Product Change Notice (PCN)

PCN Number: PCN-0374233R-01

Product(s) Affected: CSS-0575A-SMT-TR and CSS-0578-SMT-TR

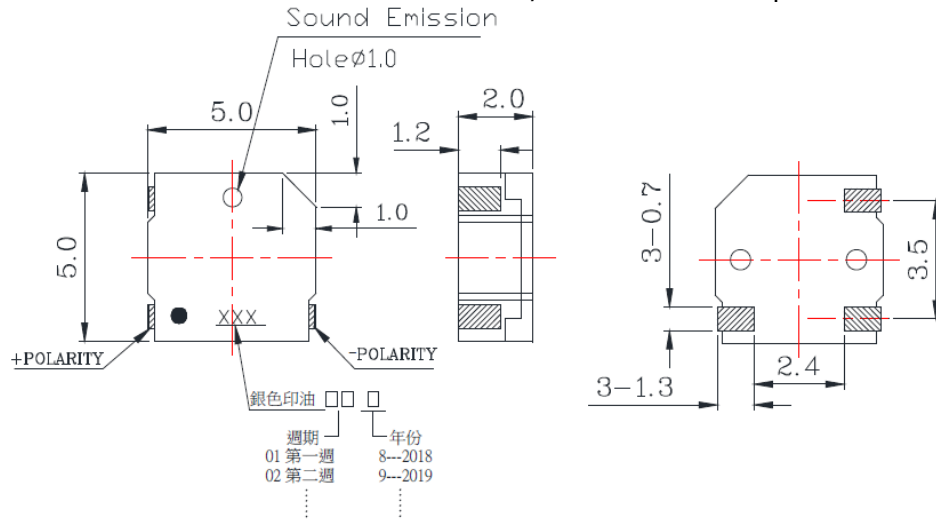
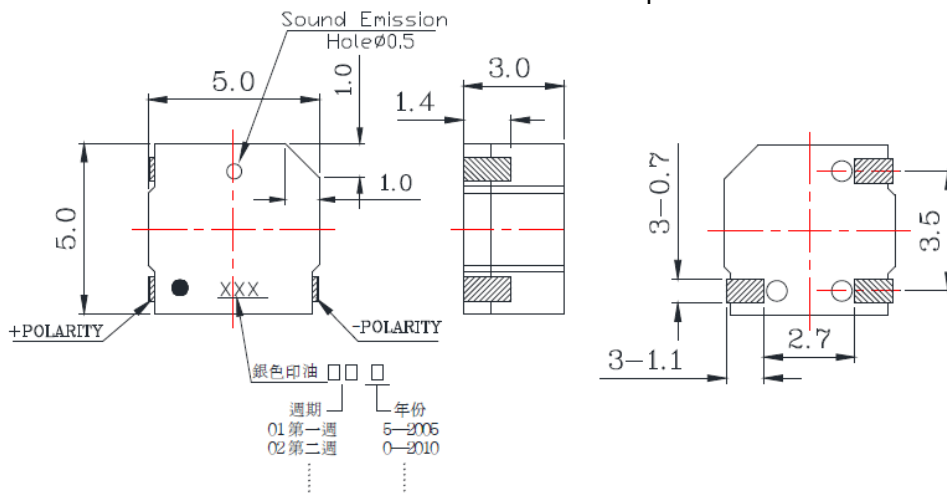
Description of Change: Tooling has been altered creating higher SPL, lower consumption current due to optimization of the structure and new dimensions are very close to the previous while the PCB layout remains the same for both parts.

CSS-0575A-SMT-TR – Previous: SPL 75 dB / Current Consumption 110

CSS-0575A-SMT-TR – New: SPL 76 dB / Current Consumption 95

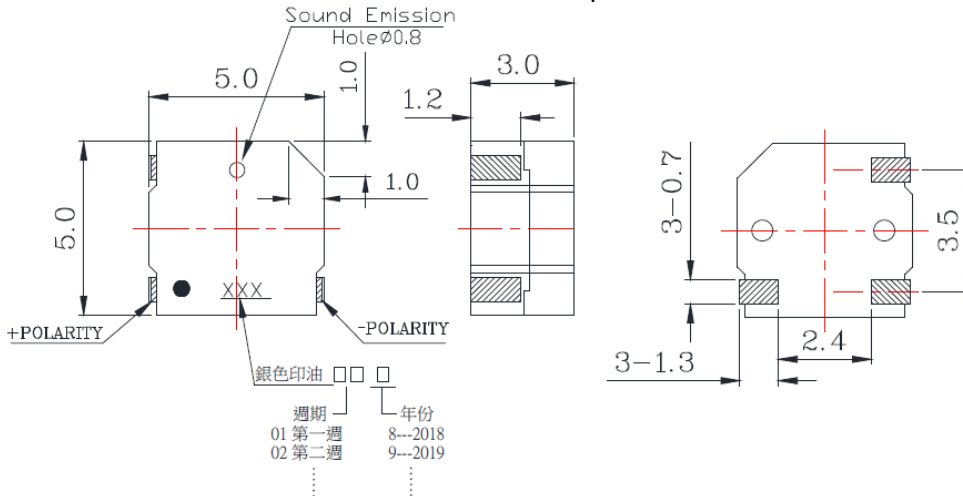
CSS-0578-SMT-TR – Previous: Current Consumption 110

CSS-0578-SMT-TR – New: Current Consumption 95
